# Written Representation - Ridgeway Users

### **Written Representation**

Figure 1 - Outfall DP4 marked with a Red Circle.

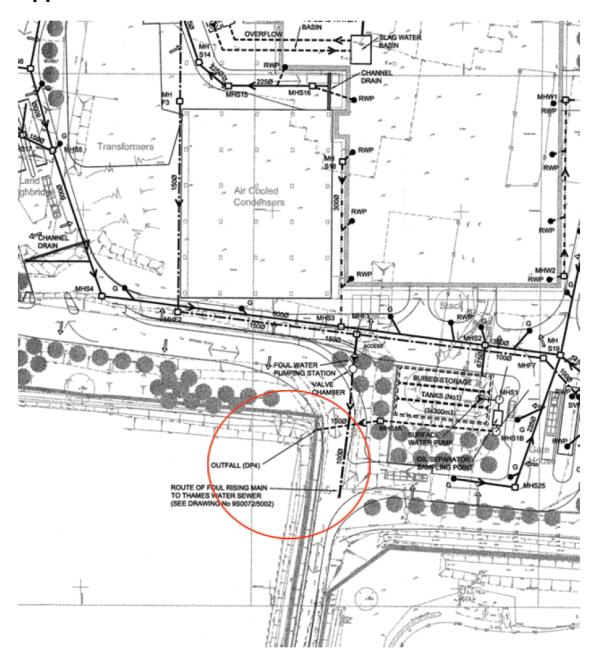
We identified the exact location of the DP4 outfall pipe from documentation found within drawings attached to planning application 99/02388/CIRC11 (Figure 1 - see appendices). It is from this location that excess water is discharged after filling the buried storage tanks and passing through the oil separators. We initially sought to collect water discharge, but due to the prolonged dry weather in March and early April, there was no outflow we could attain.

Upon preliminary visits to the site location, after shining a torch inside the pipe (Figure 2), we noticed that a quantity of reachable loose sediment had accumulated along the bottom of the pipe, mirroring fluvial discharge patterns.

**2.1.2** On the 16th April 7:30pm, Ridgeway Users gathered an additional sample of approximately 150g of loose sediment directly from the pipe used by Cory for their rainfall outflow (Figure 3).
